BRP Rotax Aircraft Engines. Sulkutulpan tarkastus ja korjaus

Koskee: Kansallisiin ilma-aluksiin asennettuja moottoreita Rotax 912 iS/iS Sport Rotax BRP alert service bulletin ASB-912 i-007iS mukaisesti.

Emergency Airworthiness Directive

Checking of the correct positioning of sealing plug in ignition housing for ROTAX® Engine Type 912 i (Series)

Fig. 3
Correcting the sealing plug position with special tool (insertion jig)

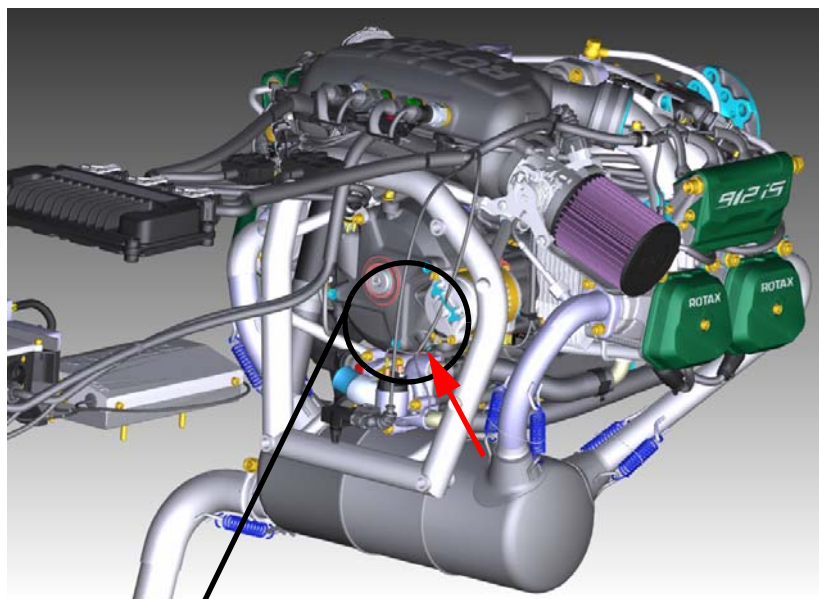
Step	Procedure
1	<p>Correct the sealing plug position with a hammer (max. 300 g / 0.66 lbs) and the relevant insertion jig part no. 676255 as per section 2.6. Intuitively control your manual insertion force just to set the ball in correct position. See Fig. 3.</p> <p>NOTE: The bore must be free of oil, grease and chips.</p> <p>NOTE: Make sure to insert the insertion jig in correct alignment of the center bore / center line of the sealing plug.</p>

Fig. 1
Sealing plug in ignition housing

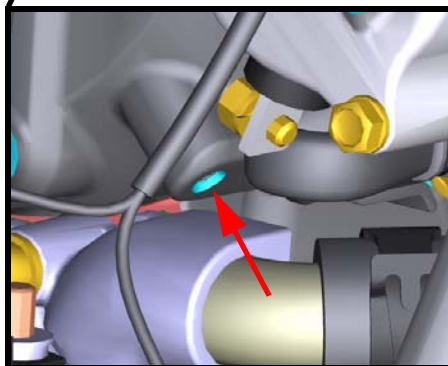
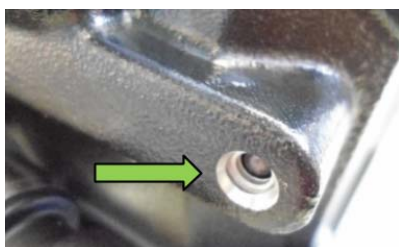
Field observation has shown that in isolated cases the sealing plug (see Fig. 1) was not pressed to its correct seating position in the ignition housing. In rare cases this may lead to loss of oil and subsequently loss of lubrication which leads to engine stoppage.

Fig. 2
Good/bad comparison of sealing plug position

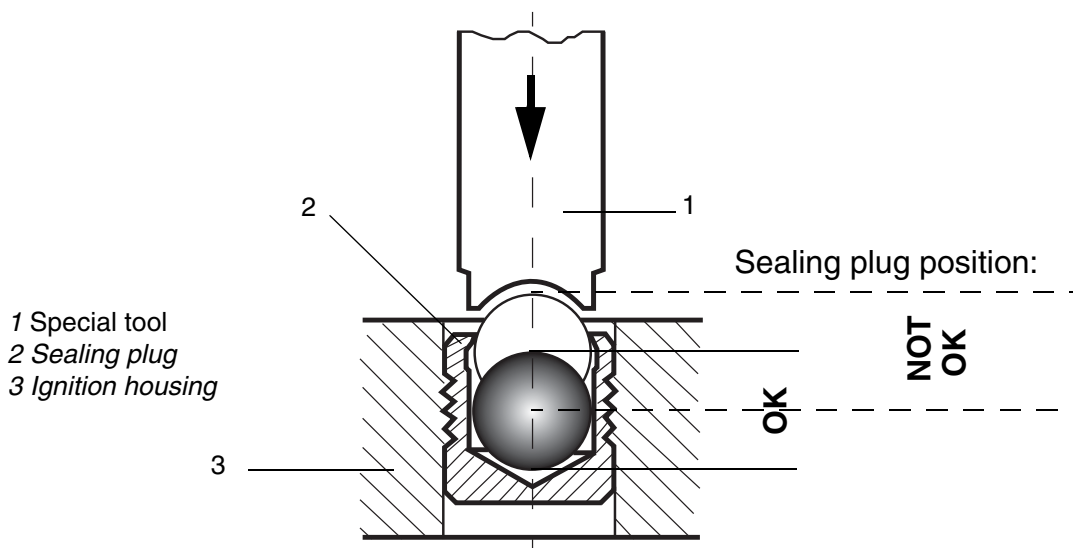
Step	Procedure
1	Check the position of sealing plug in the relevant area of ignition housing assy. See Fig. 2.
2	The sealing plug must show to have been pressed in until the top of the ball is below the edge of the sleeve. See position OK in Fig. 2.
3	If you notice sealing plug position is OK, then there is no need for further procedures. NOTE: If you notice sealing plug position is NOT OK, then see section 3.2.

3.2) Correcting sealing plug position (required if position of sealing plug is incorrect, see Fig. 2)
